# UNITED STATES PATENT AND TRADEMARK OFFICE

APPLICATION NO.	FILING DATE	FIRST NAMED INVENTOR	ATTORNEY DOCKET NO.	CONFIRMATION NO.
09/990,739	11/16/2001	David H. Harris	5087-27	3310
20575	7590	07/24/2006	EXAMINER	
MARGER JOHNSON & MCCOLLOM, P.C. 210 SW MORRISON STREET, SUITE 400 PORTLAND, OR 97204			DANG, KHANH	
			ART UNIT	PAPER NUMBER
			2111

<b>Office Action Summary</b>	<b>Application No.</b>		<b>Applicant(s)</b>	
	09/990,739		HARRIS ET AL.	
	<b>Examiner</b>		<b>Art Unit</b>	
	Khanh Dang		2111

### **DETAILED ACTION**

**Fig. 1 of Kobayashi:**

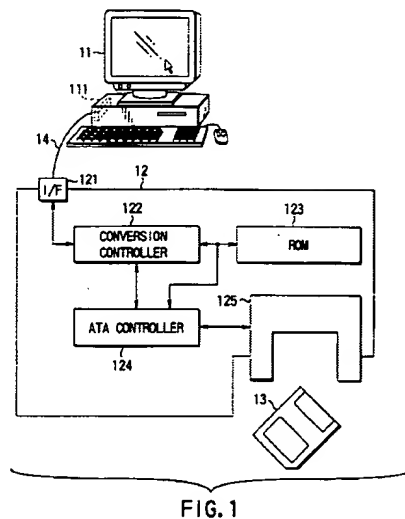
Note that the single chip conversion controller 122 or the so-called "bridge circuit" is provided on the motherboard of the storage device 12.

**Fig. 2 of the instant Application:**

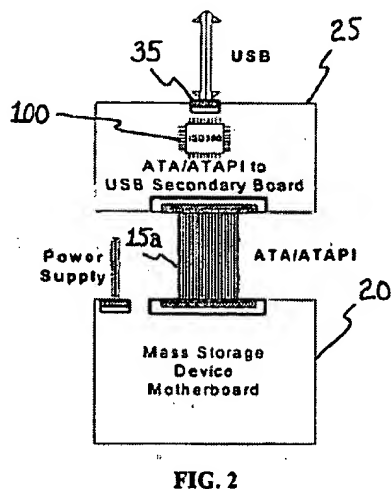
Note that the so-called "bridge circuit" (single chip) 100 is provided on a separate "secondary" board 25, instead of on the motherboard 20 of the storage device.

FIG. 3

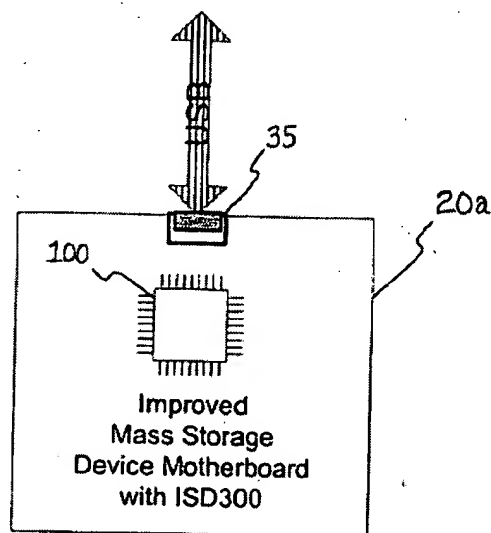
However, it is clear that whether the single chip conversion controller 122 or the so-called "bridge circuit" is provided on the motherboard of the storage device as in Kobayashi, or provided on a separate or "secondary" board as in claim 5, the conversion controller 122 would perform the same function, which is a function of converting between the ATA/ATAPI protocol to the USB protocol and vice versa. As matter of fact, as disclosed in Applicants' summary of the Invention, the crux of Applicants' claimed invention is a single bridging chip for converting ATA/ATAPI protocol to USB protocol and vice versa. The bridging circuit/chip 100 would perform the same function whether the bridging chip 100 is provided on a motherboard of the storage device (page 2, lines 8-12 of the originally filed specification, and Fig. 3):

FIG. 2

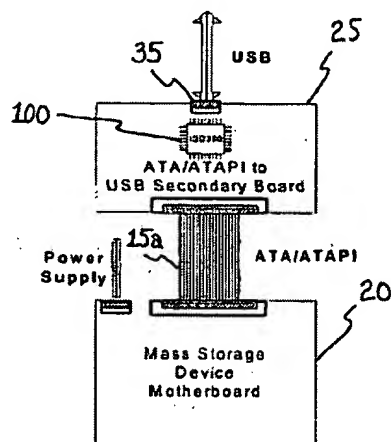
or, **alternatively**, as a design choice, the bridging chip 100 is provided on a secondary board (see page 2, lines 17-21 of the originally filed specification, and Fig. 2)

Thus, it would have been obvious to one of ordinary skill in the art at the time the invention was made to use a separate or "secondary" board for the single chip conversion controller 122 of Kobayashi, since the conversion controller chip 122 of Kobayashi would perform the same function whether on the same board with the storage device 12 or on a separate or "secondary board" and, thus, providing a separate or "secondary board" for the single chip conversion controller 122 of Kobayashi is a matter of design choice, as also acknowledged by Applicants, and only involves ordinary skill in the art.

**Fig. 1 of Kobayashi:**

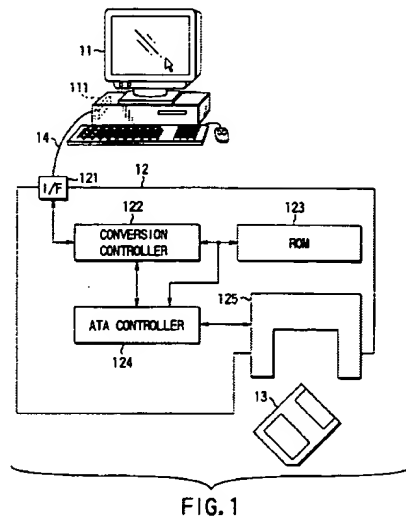
Note that the single chip conversion controller 122 or the so-called “bridge circuit” is provided on the motherboard of the storage device 12.

**Fig. 2 of the instant Application:**

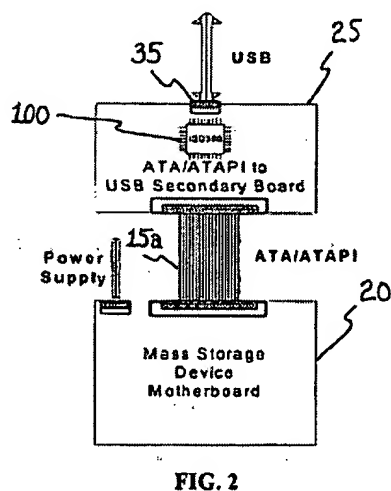
Note that the so-called “bridge circuit” (single chip) 100 is provided on a separate “secondary” board 25, instead of on the motherboard 20 of the storage device.

FIG. 3

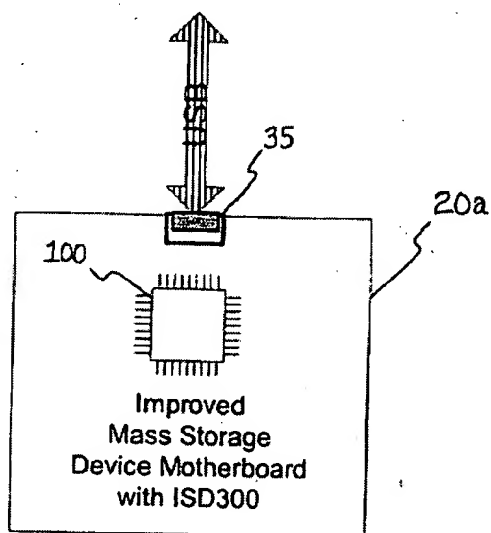
However, it is clear that whether the single chip conversion controller 122 or the so-called "bridge circuit" is provided on the motherboard of the storage device as in Kobayashi, or provided on a separate or "secondary" board as in claim 5, the conversion controller 122 would perform the same function, which is a function of converting between the ATA/ATAPI protocol to the USB protocol and vice versa. As matter of fact, as disclosed in Applicants' summary of the Invention, the crux of Applicants' claimed invention is a single bridging chip for converting ATA/ATAPI protocol to USB protocol and vice versa. The bridging circuit/chip 100 would perform the same function whether the bridging chip 100 is provided on a motherboard of the storage device (page 2, lines 8-12 of the originally filed specification, and Fig. 3):

FIG. 2

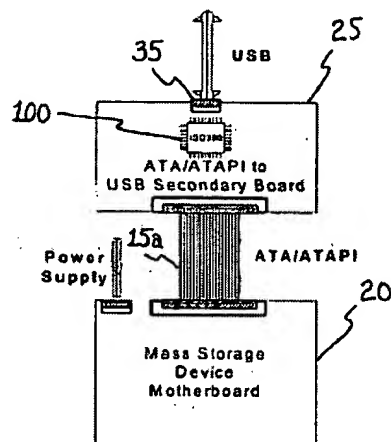
or, **alternatively**, as a design choice, the bridging chip 100 is provided on a secondary board (see page 2, lines 17-21 of the originally filed specification, and Fig. 2)

Thus, it would have been obvious to one of ordinary skill in the art at the time the invention was made to use a separate or "secondary" board for the single chip conversion controller 122 of Kobayashi, since the conversion controller chip 122 of Kobayashi would perform the same function whether on the same board with the storage device 12 or on a separate or "secondary board" and, thus, providing a separate or "secondary board" for the single chip conversion controller 122 of Kobayashi is a matter of design choice, as also acknowledged by Applicants, and only involves ordinary skill in the art. With regard to claim 9, note that it is clear that it is clearly inherent that the separate or "secondary" board must include a "connector port" for receiving signals from the mass storage device motherboard, and a USB "connector
